Access Compliance Report Public Rights-of-Way (Pedestrian Signals)

Intersection ID: N/A	Main Street:	Cross Street: N/A	Location: N/A
ADA ID: 6729E90705EF	Signal Type: One Push Button-Non APS	Overall Compliance: No	Severity Score: BTN 1: N/A BTN 2: N/A No BTN: N/A
Codes/Mitigation Info/Possible Solution		Field Measurements/Component Compliance

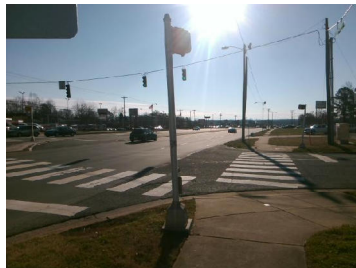
PROW/ADA: TMUTCD 4e.08, R404.2, R406.2

Compliance	Description	Data	Compliance	Description	Data
	Button Count	Button1	Yes	Distant to Additional Button (in)	205.0
	Additional Button Present?	Yes		Additional Button ID	F2C1237B824D
N/A	Signal Buttons Required?	N/A	N/A	Additional Ped Posts Required	N/A
	How Many Ped Street Xings?	2		Located In An Island/Median?	No
N/A	B 1 Sign Present?	Yes	N/A	B 2 Sign Present?	N/A
Yes	B 1 Sign Purpose?	Yes	N/A	B 2 Sign Purpose?	N/A
Yes	B 1 Sign Lettering & Contrast?	Yes	N/A	B 2 Sign Lettering & Contrast?	N/A
Yes	B 1 Parallel To XWalk?	Yes	N/A	B 2 Parallel To XWalk?	N/A
Yes	B 1 PAR to Button?	Yes	N/A	B 2 PAR to Button?	N/A
Yes	B 1 PAR to XWalk?	Yes	N/A	B 2 PAR to XWalk?	N/A
Yes	B 1 Clear Floor Space?	Yes	N/A	B 2 Clear Floor Space?	N/A
N/A	B 1 FWD Approach?	Yes	N/A	B 2 FWD Approach?	N/A
N/A	B 1 FWD Approach Constrained?	No	N/A	B 2 FWD Approach Constrained?	N/A
No	B 1 FWD Approach Reach (in)	17.0	N/A	B 2 FWD Approach Reach (in)	N/A

N/A	B 1 FWD Approach Width (in)	N/A	N/A	B 2 FWD Approach Width (in)	N/A
N/A	B 1 FWD Approach Obstruction?	Yes	N/A	B 2 FWD Approach Obstruction?	N/A
N/A	B 1 FWD Approach Obstruction Dist (in)	12.0	N/A	B 2 FWD Approach ObstructionDist (in)	N/A
N/A	B 1 PARA Approach?	Yes	N/A	B 2 PARA Approach?	N/A
N/A	B 1 PARA Approach Constrained?	No	N/A	B 2 PARA Approach Constrained?	N/A
Yes	B 1 PARA Approach Reach (in)	8.0	N/A	B 2 PARA Approach Reach (in)	N/A
N/A	B 1 PARA Approach Width (in)	N/A	N/A	B 2 PARA Approach Width (in)	N/A
N/A	B 1 PARA Approach Obstruction?	Yes	N/A	B 2 PARA Approach Obstruction?	N/A
N/A	B 1 PARA Approach Obstruction Dist (in)	4.0	N/A	B 2 PARA Approach ObstructionDist (in)	N/A
Yes	B 1 Clear Floor Space Slope (%)	1.4	N/A	B 2 Clear Floor Space Slope (%)	N/A
No	B 1 Clear Floor Space XSlope (%)	5.3	N/A	B 2 Clear Floor Space XSlope (%)	N/A
N/A	B 1 PAR Slope (%)	2.7	N/A	B 2 PAR Slope (%)	N/A
Yes	B 1 Height (in)	39.0	N/A	B 2 Height (in)	N/A

Yes	B 1 Clear Xing Direction?	ClearlyMarked	N/A	B 2 Clear Xing Direction?	N/A
	B 1 Crossing Direction	To NE		B 2 Crossing Direction	N/A
No	B 1 DistanceTo XWalk (in)	93.0	N/A	B 2 DistanceTo XWalk (in)	N/A
Yes	B 1 DistanceTo Curb (in)	64.0	N/A	B 2 DistanceTo Curb (in)	N/A
Yes	B 1 Diameter (in)	2.0	N/A	B 2 Diameter (in)	N/A

Possible Solutions: Replace Signal Push Button With APS Button on New Post. Remove & Relocate Sign.
